A1 in Northumberland: Morpeth to Ellingham

7.6A Statement of Common Ground with Northumberland County Council

**Statement of Common Ground with
Northumberland County Council**

Rule Reference:	8(1)(e)
Planning Inspectorate Scheme Reference:	TR010059
Doc Reference:	7.6A
Author:	A1 in Northumberland: Morpeth to Ellingham Project Team, Highways England

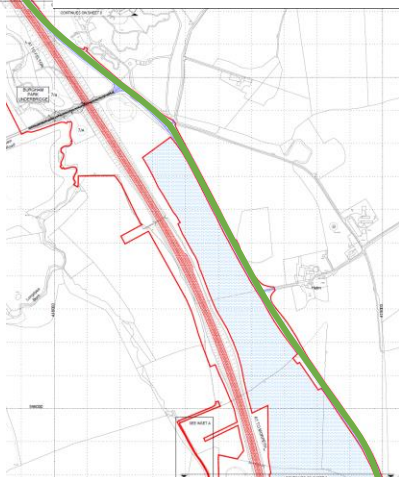
Footway/Cycleway as shown
On PRow and Access Plans
Constructed in accordance
With NCC Cross Section

New Footway/Cycleway to
Continue from Northern
Section Constructed to NCC
Cross Section Requirements

Footway connection
from overbridge footway
to existing footway on
de-trunked A1

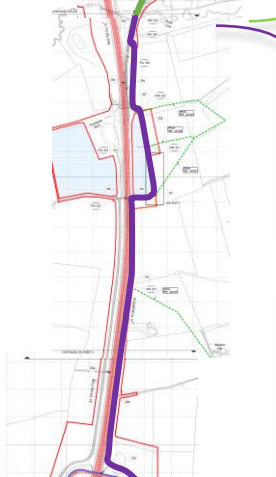
Existing Footway to be
Incorporated into New
Footway/Cycleway to NCC
Cross Section Requirements

Footway connection
from junction footway to
existing footway on de-
trunked A1

New Footway/Cycleway to
Continue Constructed to NCC
Cross Section Requirements

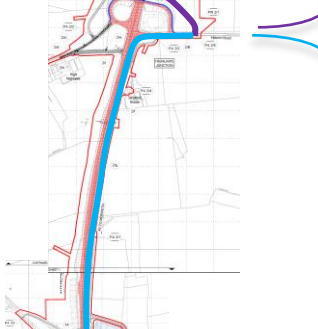
New Footway/Cycleway to
Utilise Existing and Proposed
PRow Routing to Continue
Linkage - design to be agreed

New / Existing Footway
Be Widened to Allow
Footway/Cycleway
Designation
